• Target year			
₦ 2025, 2020)		
PDP			
Candidates	s are based	on IE plan	
Demand For	recast		
Demand Fo	recast 2015	2020	2025
		2020 48,642	2025 71,416
Peak (MW)	2015		and the second second second second
Peak (MW) Energy(GWh)	2015 32,196	48,642	71,416
Demand For Peak (MW) Energy(GWh) North (MW) Central (MW)	2015 32,196 190,047	48,642 294,012	71,41 <i>6</i> 431,664

Comments & Recommendations

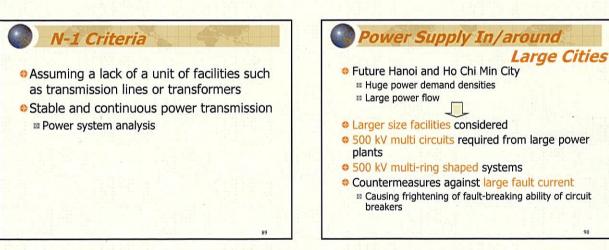
- Reliability criteria could be applied RM criteria. N 7-8%, C&S 10%
- Economical Interconnection capacity around 1000MW
- Review Firm Peak Capacity of Hydropower in dry season based on actual records
- BOT scheme has limitation up to 1440MW due to fuel limitation, if CF=75% contract remaining
